SUBJECT: Request for Additional Information Related to Requests for Relief from  
American Society of Mechanical Engineers (ASME) Section XI Volumetric  
Examination Requirements – Fourth 10-Year Interval, First Period  
Arkansas Nuclear One, Unit 2  
Docket No. 50-368  
License No. NPF-6

**Response to Request for Additional Information (RAI)  
Relief Request Numbers ANO2-ISI-018 and ANO2-ISI-019**

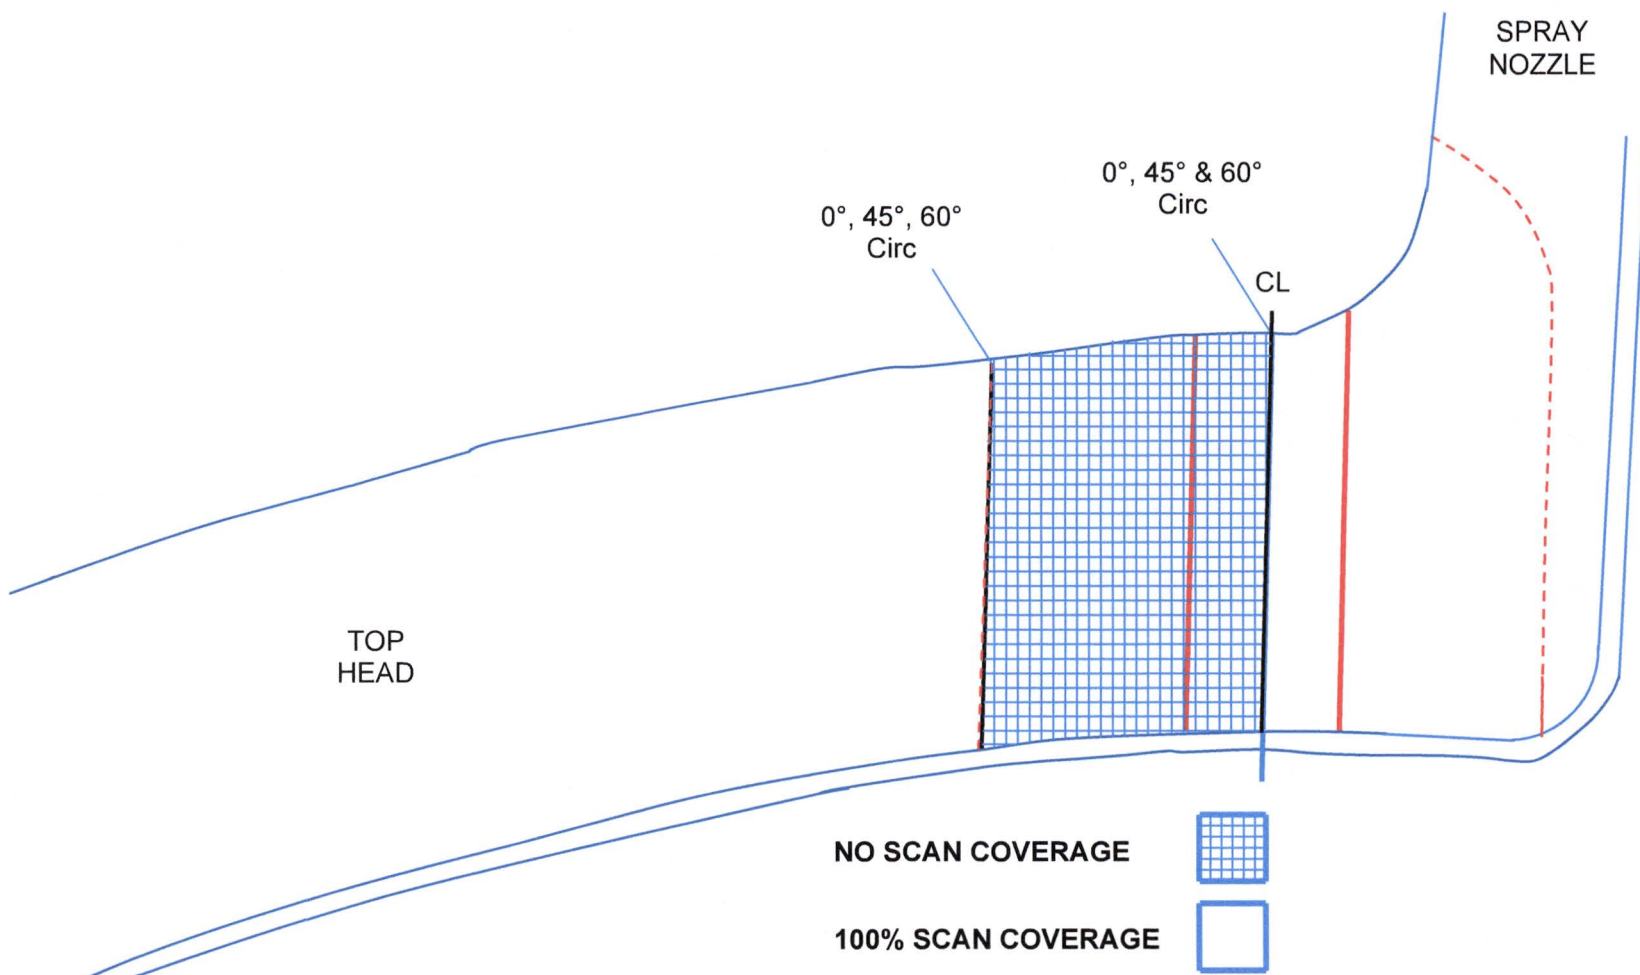
- a) The coverage diagrams in Figures 1 through 4 of relief request number ANO2-ISI-018 and in Figures 1 and 2 of relief request number ANO2-ISI-019 do not provide sufficient detail for the staff to evaluate the examination coverage obtained. For an example of what the staff deems as clear information in a coverage diagram, please refer to slide 12 of the "Coverage Relief Requests" presentation (ADAMS Accession No. ML15013A266) given by the staff during an Industry/NRC Information Exchange Public Meeting held on January 13-15, 2015. Please include separate diagrams for the "Axial Scan" and "Circumferential Scan" coverages as shown in the example.

With respect to request for relief ANO2-ISI-018; Figures 1 through 4 of the original Entergy request (Reference 1) have been subdivided such that each of the four figures will now involve one figure illustrating the Axial Scan coverage and one illustrating the Circumferential Scan coverage. These figures are included below.

**Circumferential Scan Plan and Coverage for Component 05-010**  
Not to Scale

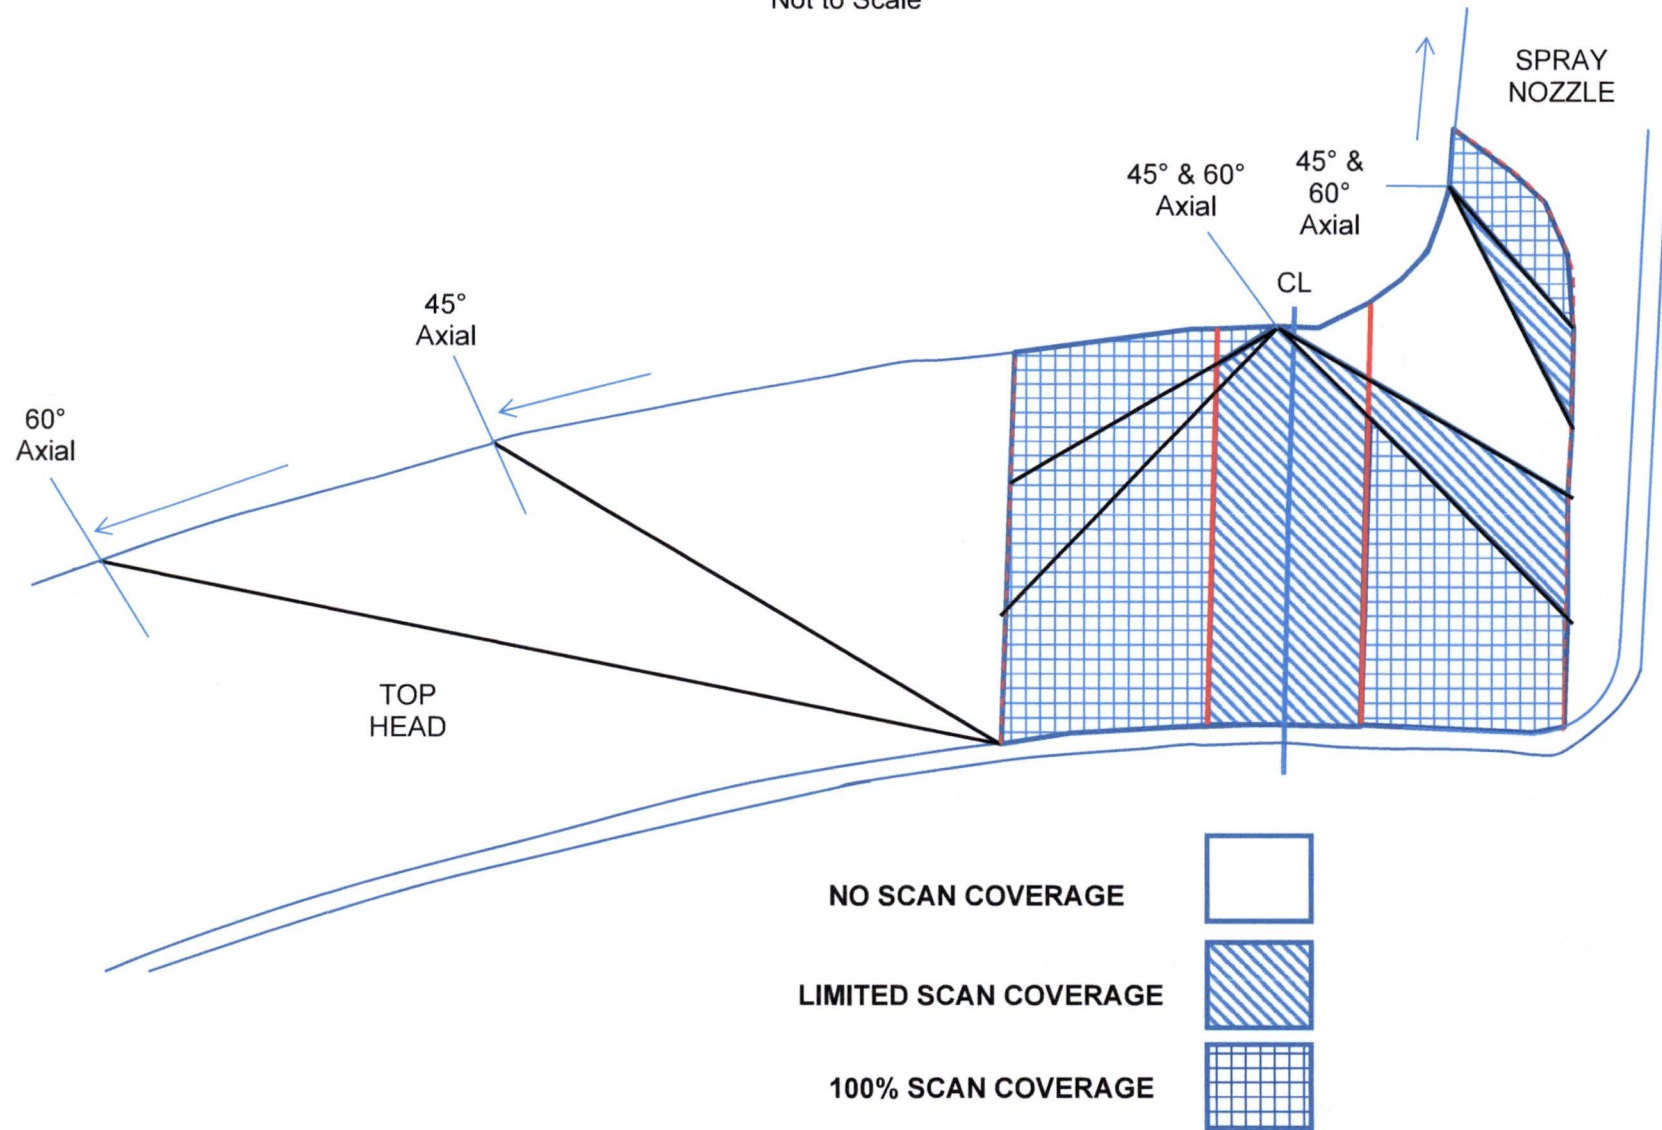
- c) With respect to relief request number ANO2-ISI-018, under the "Axial Scan Coverage" in Figures 1 through 4, where it indicates "Metal", please clarify if this is meant to be "Weld Metal".

Where "metal" was stated in Figures 1 through 4, it was intended to describe "weld metal".

**Circumferential Scan Plan and Coverage for Component 05-011**  
Not to Scale

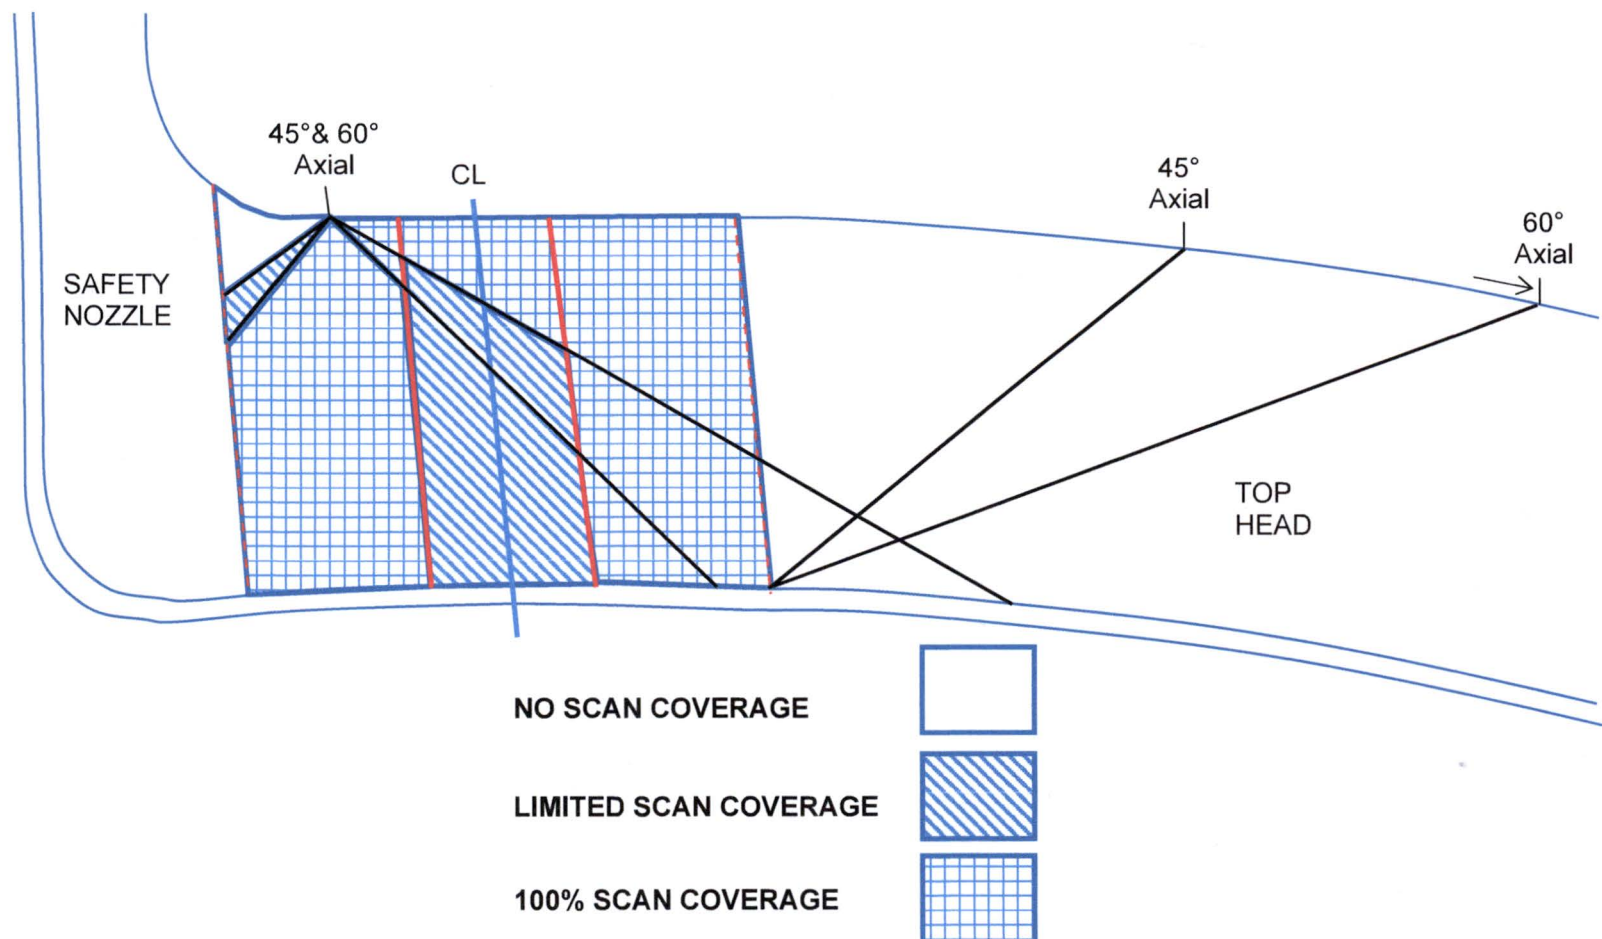
- b) With respect to relief request number ANO2-ISI-018, explain how the values for "factor for limitation" in Figures 2 through 4 were determined and why there was no "factor for limitation" applied in Figure 1.

With respect to Attachment 1, Figures 1 through 4 of the Reference 1 request for relief ANO2-ISI-018, the "factors for limitation" values listed in Figures 2 through 4 were taken from previous data considering possible limitations from adjacent nozzles or an upending lug. The technician performing the estimated ultrasonic coverage calculations applied that factor as a measure of conservatism on the safety nozzles (Figures 2 through 4) that are on the slope of the pressurizer vessel head. The spray nozzle is depicted in Figure 1 and is in the center of the pressurizer vessel head. The technician did not apply a factor of limitation to that weld scan coverage estimation as the nozzle weld has uniform geometry. The scans for all 4 nozzle welds depicted in Figures 1 through 4 achieved the maximum scan coverage with the required angles, considering the primary scan direction is from the vessel head. The prominent limitation for all nozzle welds is the limitation to scan the weld area from the nozzle side due to geometric configuration. The weld areas received essentially 100% scan coverage from the vessel head side.
